MKT 72. Response to TD comments

A/NE-MKT/72

Run in / out Design Proposal

Project Name: Proposed Temporary Warehouse for Storage of Car Parts (Coaches Only) and Associated Filling of Land for a Period of 3 Years

平面圖 SITE PLAN

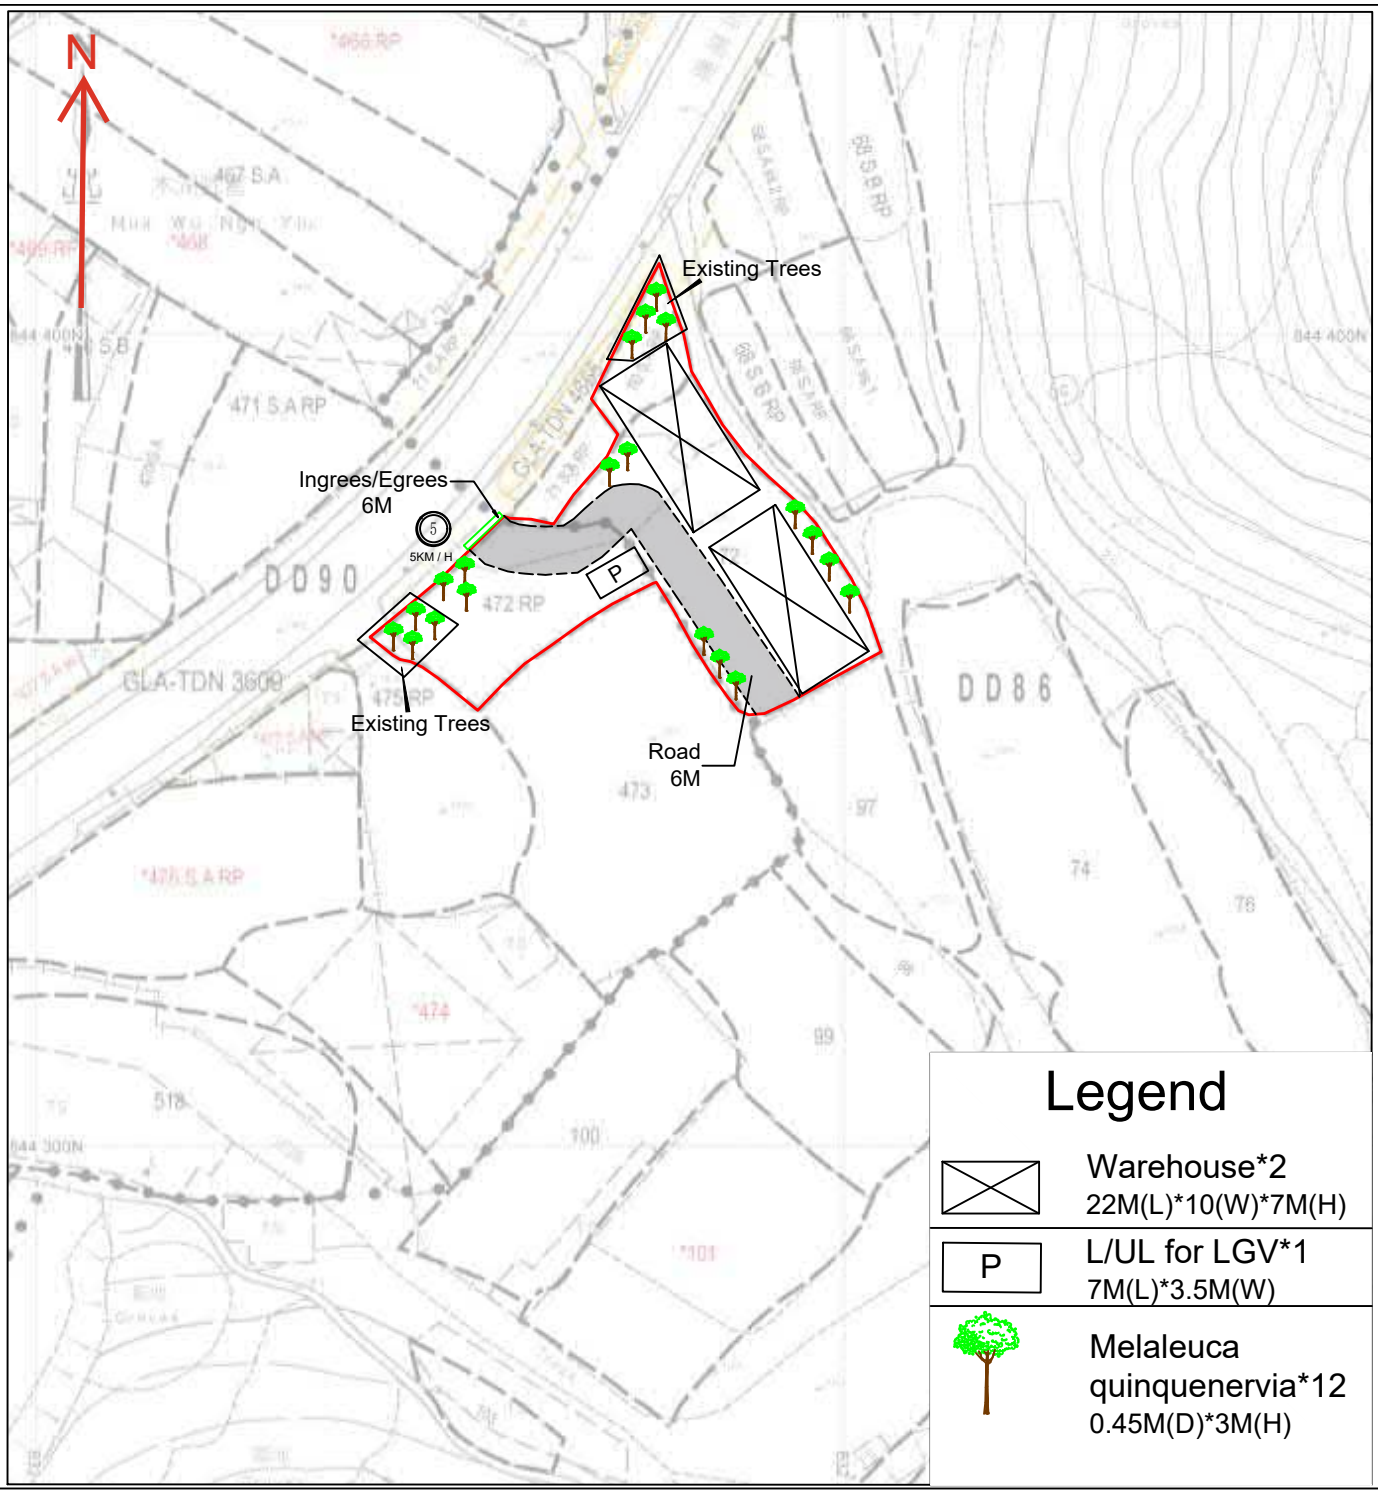
Comment 2
The applicant shall demonstrate the satisfactory maneuvering of the vehicles existing the application site (the Site) without the need to encroach onto the opposite lane preferably using the swept path analysis;
Response
Please refer to swept path plan

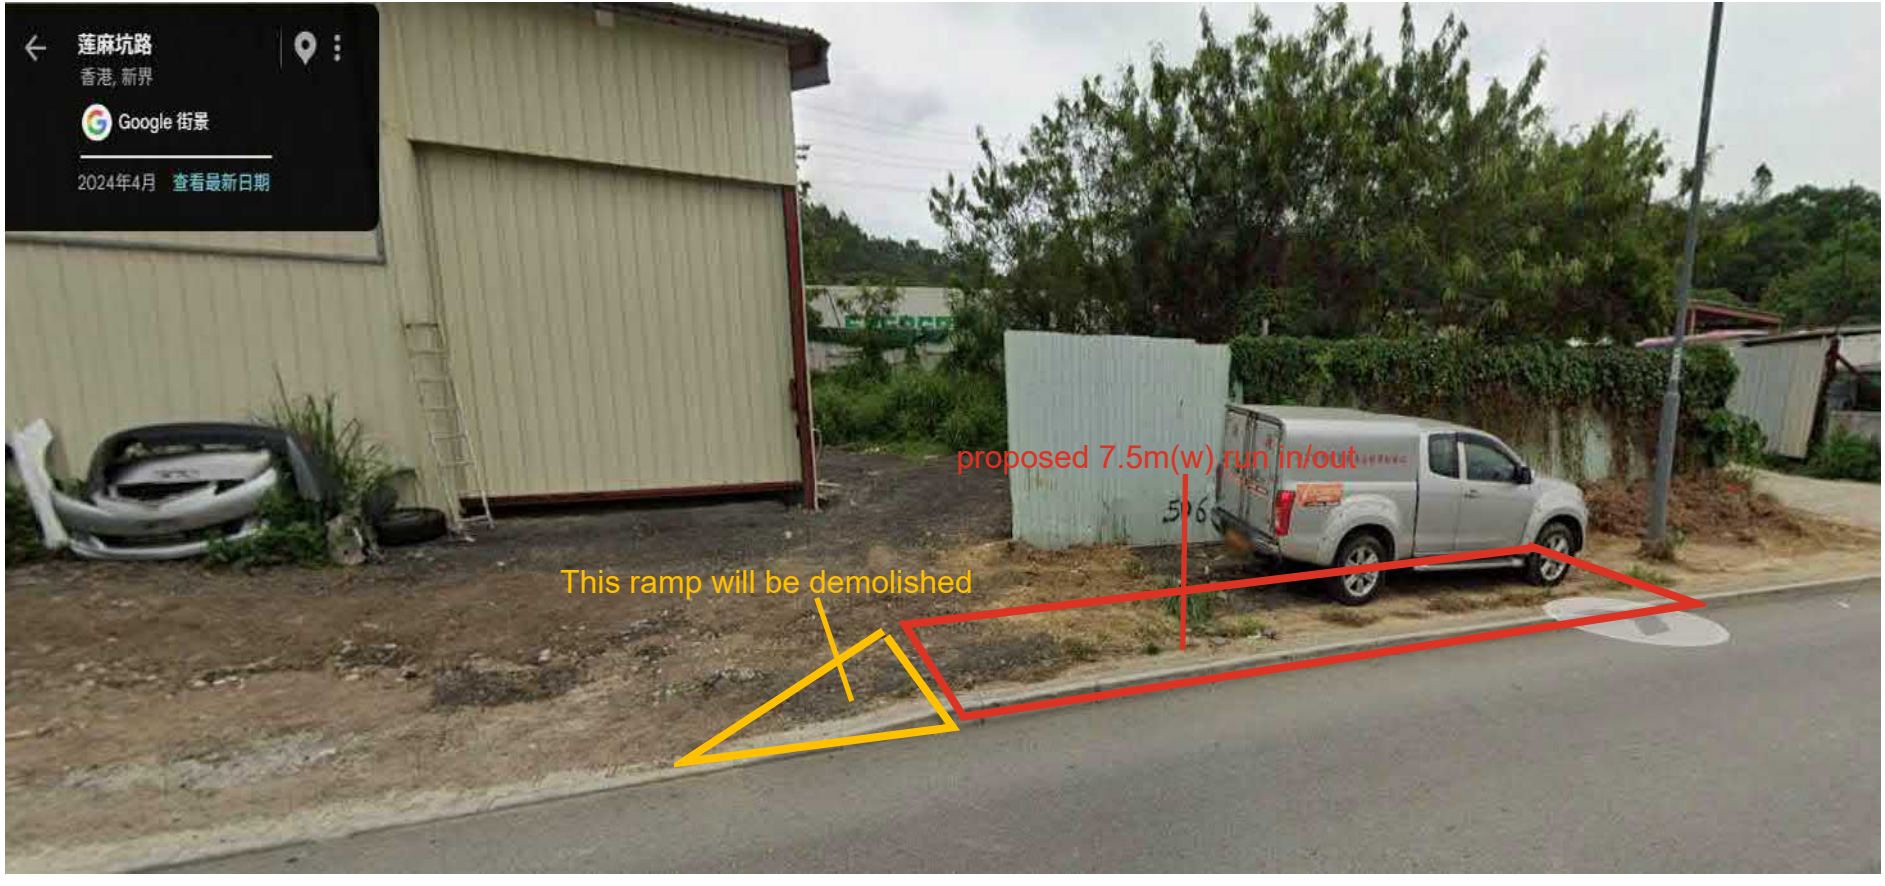
Comment 3
The applicant shall provide a proposal on the vehicular access arrangement including the run-in/out design for the vehicles leaving/entering the Site;
Response
Please refer to vehicular access arrangement proposal

莲麻坑路
香港, 新界
Google 街景
2024年4月 查看最新日期
proposed 7.5m(w) run in/out
This ramp will be demolished
